**AMENDMENT NO. 2
TO THE
CONSTRUCTION SERVICES CONTRACT
BETWEEN
THE TEXAS FACILITIES COMMISSION
AND
VEIT & COMPANY, INC.**

Exhibit D-6

Job Name: G.J. Sutton Complex Building Demolition

BASEMENT FOUNDATION
DEMOLITION PLAN -
MAIN BUILDING

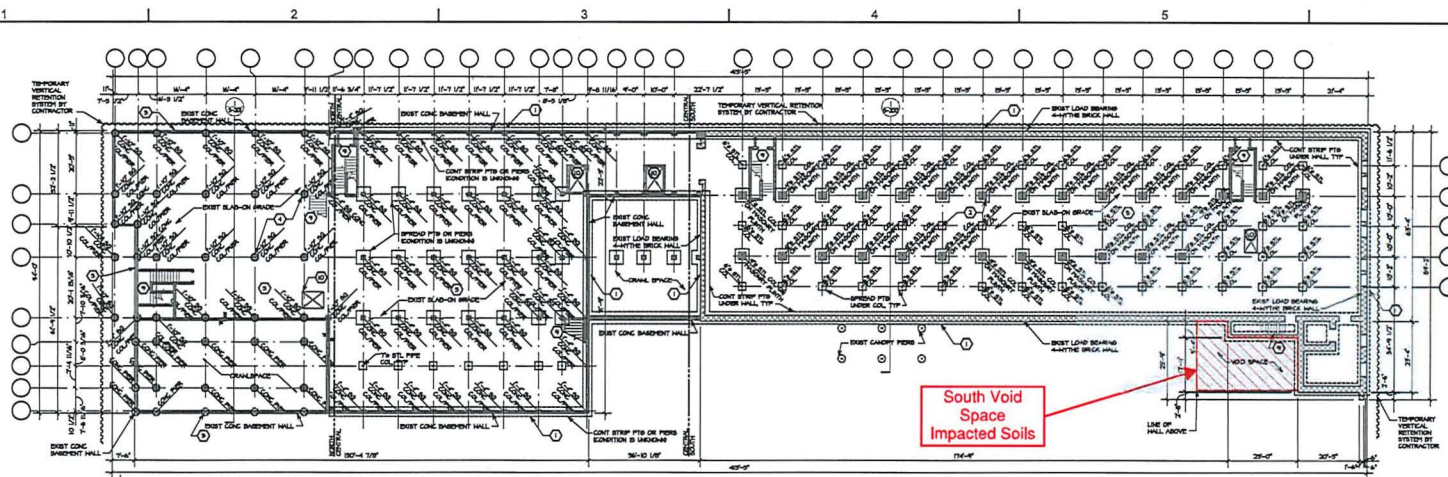
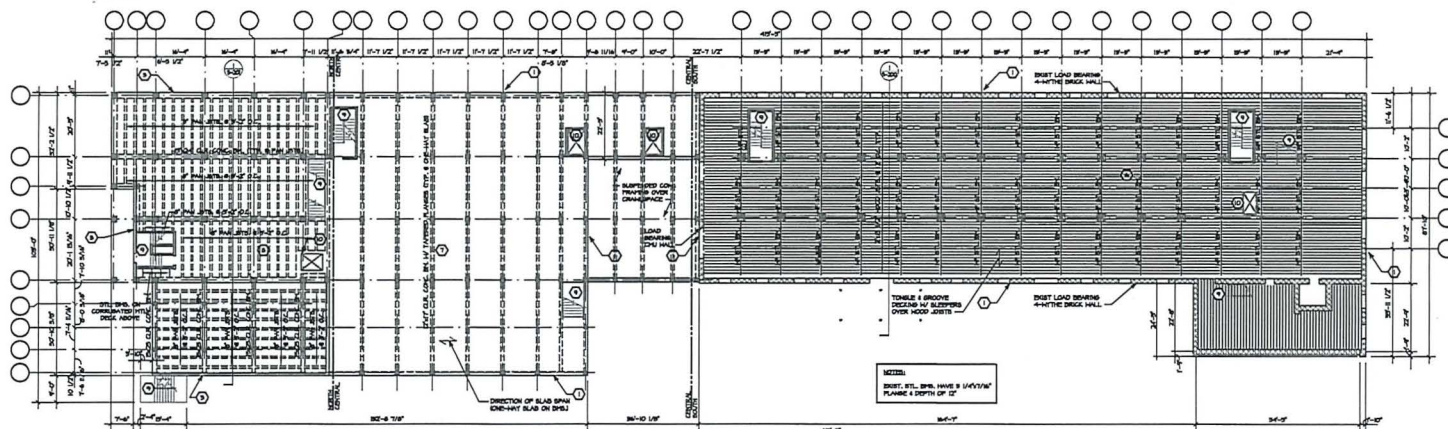
This proposed change order (PCO) request is for additional costs associated with loading, hauling, & disposal of unknown impacted soils that were encountered within three areas (South Void Space of Main Building, Area Just North of the South Void Space, and Former Annex Building). This also includes additional backfill and compaction to replace the impacted/removed soils.

REASON: Additional impacted soils discovered in three areas of site.

JUSTIFICATION: Soils tested at these locations were not known to be contaminated. Soils will be removed and disposed of and the voids will be properly filled and compacted.
